Addendum No. 1

Peckham and White Fir Truck Fill Stations

Bid # 0910-198
March 08, 2010

**Reference: TMWA – Peckham Lane Truck Fill Station Landscape Plans
Addendum 1**

3 RECYCLED PLASTIC EDGER

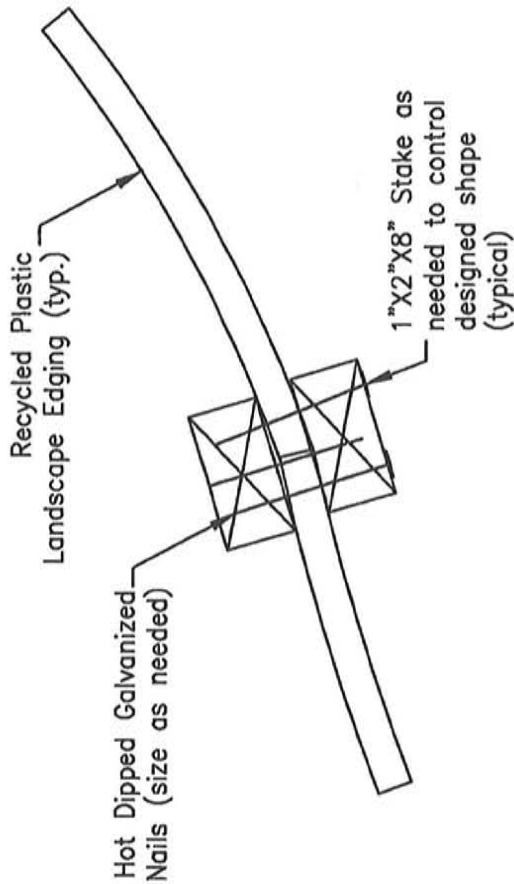
1. Sheet L2 – Planting Details
 - a. Detail 3 - Recycled Plastic Edger. Refer to Attachment A for changes to the detail.
2. Sheet I1 – Irrigation Plan
 - a. Detail 1 – Manual and Automatic Drain. Add to the detail the following note: "Locate manual drains at low points, a minimum of one drain per lateral."

1. Edger shall be 2"x4"x8" tan colored recycled plastic material.
2. Layout edger pattern in true arcs and tangents per plans and contact landscape architect for approval prior to construction.
3. Stake all ends/both sides per manufacturer's recommendations.

RPPA/BACKFLOW PREVENTOR

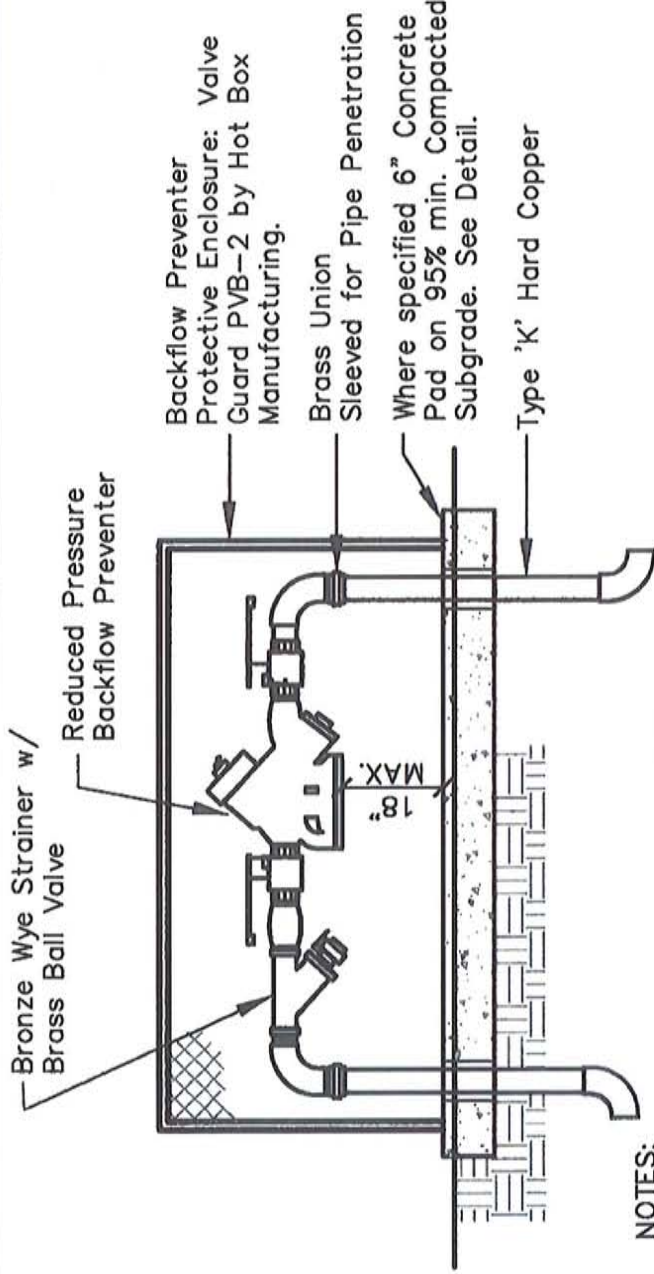
- b. Add the RPPA/Backflow Preventer detail as Detail 8. Refer to Attachment B.
 - c. Detail 1 – Point of Connection Diagram. The 2" SCH. 40 PVC Main line shall be a minimum depth of 36", not 30".

1. All pipe fittings to be Type 'K' Copper.
2. Backflow prevention installation must be level and installed a minimum and maximum of 12" from relief port to final grade.
3. Test cocks (4) shall be fitted with brass plugs and installed with teflon tape.
4. Shutoff valves to be resilient ball type with removable handles.
5. Compression type fittings are not allowed.
6. A copper/brass union must be installed in the middle of a downstream riser.
7. Assembly shall be approved by University of Southern California Foundation for Cross Connection Control and Hydraulic Research.

3 RECYCLED PLASTIC EDGER

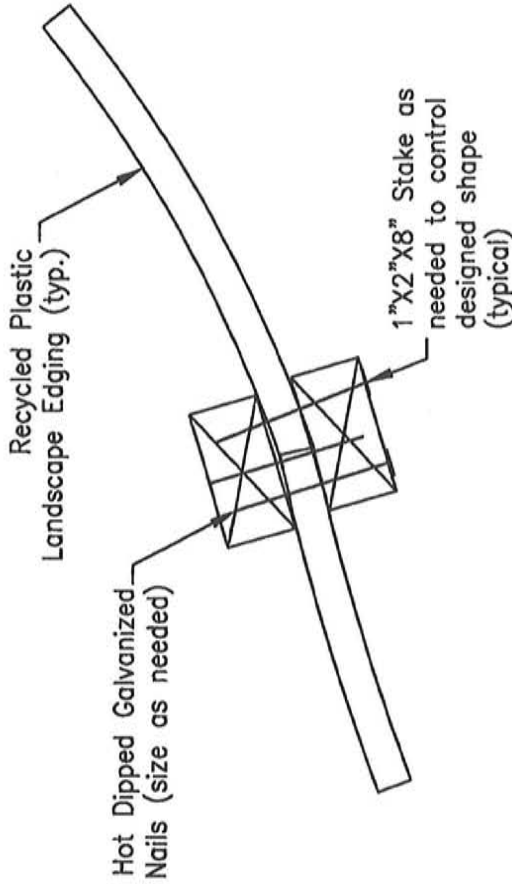
1. Sheet L2 – Planting Details
 - a. Detail 3 - Recycled Plastic Edger. Refer to Attachment A for changes to the detail.

1. Edger shall be 2" x 4" x 8" tan colored recycled plastic material.
2. Layout edger pattern in true arcs and tangents per plans and contact landscape architect for approval prior to construction.
3. Stake all ends/both sides per manufacturer's recommendations.

RPPA/BACKFLOW PREVENTER

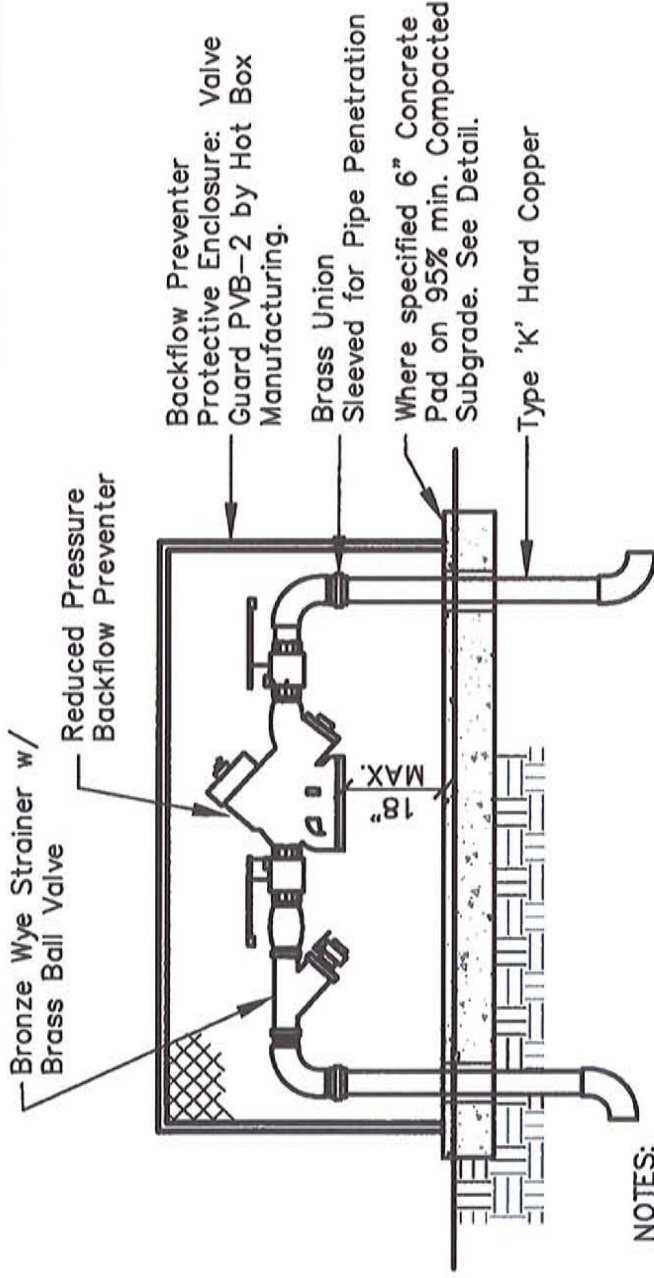
3. Sheet I2 – Irrigation Details
 - a. Remove Detail 8 – Drip Flush End Cap and place on sheet I1 as Detail 2.
 - b. Add the RPPA/Backflow Preventer detail as Detail 8. Refer to Attachment B.
 - c. Change Detail 6 from a Wall Mounted Controller to an Electrical Panel Mounted Controller. Refer to Attachment C.
 - d. Detail 1 – Point of Connection Diagram. The 2" SCH. 40 PVC Main line shall be a minimum depth of 36", not 30".
 - e. Remove note number 16 and re-number the remaining notes accordingly.
 - f. Note 25 Temporary Spray Irrigation should read: "25. Temporary Spray Irrigation: Bury laterals to 18" minimum depth. Irrigation system shall be designed to provide water without rills, gullies or erosion to surface. System shall be in place for 2 years or until revegetation is accepted by owner."

1. All pipe fittings to be Type 'K' Copper.
2. Backflow prevention installation must be level and installed a minimum and maximum of 12" from relief port to final grade.
3. Test cocks (4) shall be fitted with brass plugs and installed with teflon tape.
4. Shutoff valves to be resilient ball type with removable handles.
5. Compression type fittings are not allowed.
6. A copper/brass union must be installed in the middle of a downstream riser.
7. Assembly shall be approved by University of Southern California Foundation for Cross Connection Control and Hydraulic Research.
